## Product / Process Change Notification (PCN)

**PCN #:** PCN\_WL-SFRW\_20190520

**Affected Series:** WL-SFRW; 156120M173000

Before:

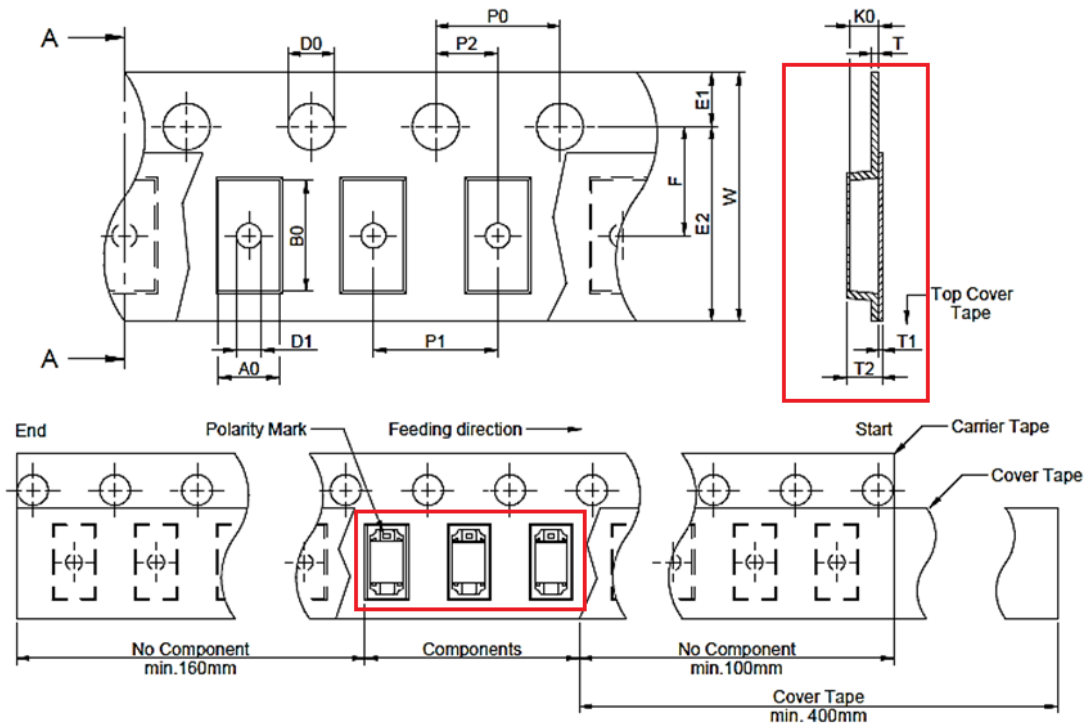
Because of a database mismatch, Würth Elektronik corrected the drawing of packaging. The packaging itself didn't change
